## 69. Introduction to Ethernet operation over electrical backplanes

### 69.1.1 Scope

**Figure 69–1—Architectural positioning of 1 Gb/s and 10 Gb/s Backplane Ethernet**

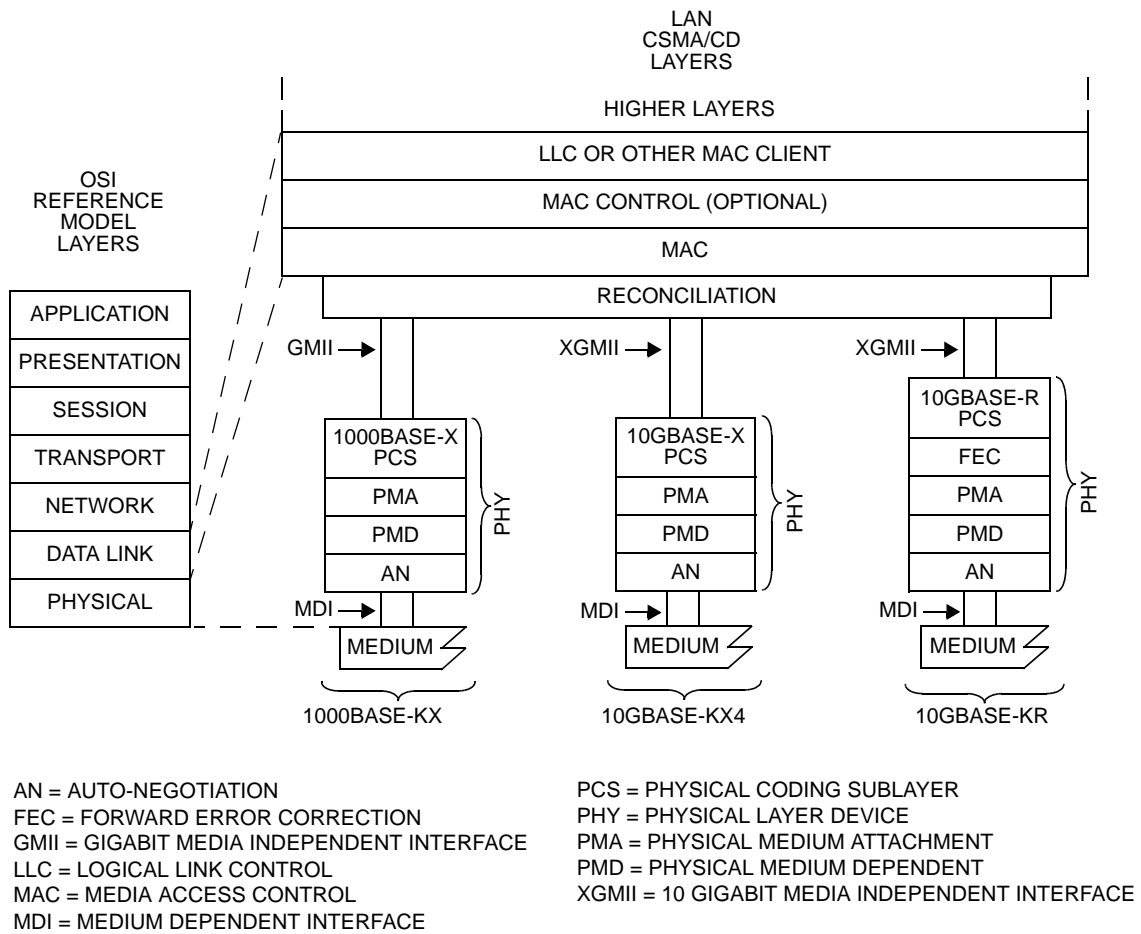
*Change Figure 69-1 and insert Figure 69-1a as shown:*
